## Questions from People for the Plains representative

### Narrabri Gas Project CCC Meeting – September 2018

#### Questions to Santos

Figure 1

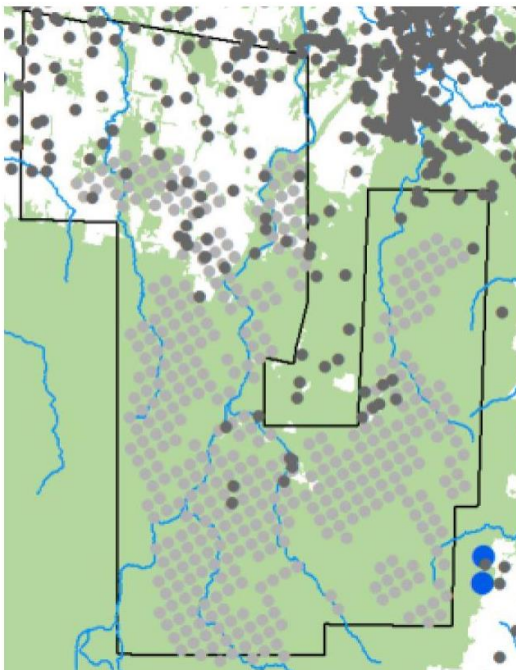
**Q. Is the figure 1, taken from a current GISERA Report, a true and accurate representation of the Narrabri Gas Project - Gas Field for which Santos has provided an EIS in February of 2017 (purple dots are used to indicate the gas wells, black dots are in the main, shallow private stock and domestic bores)?**

The image referred to appears to have been extracted from *Figure 6: Percentiles of predicted drawdown in model layer 6 corresponding to the GAB aquifer Pilliga Sandstone obtained using the highly parameterized modelling approach* from page 24 of the GISERA report published in May 2018 with reference:

The GISERA report states in Section 2.1 on page 15 that “The parameterisation is intended to reflect a generic case of coal seam gas development from the Pilliga forest area.” (emphasis added).

Therefore, although the boundary highlighted in the figure appears to be that of the Narrabri Gas Project Area, the report is based on a **generic** case of coal seam gas development.
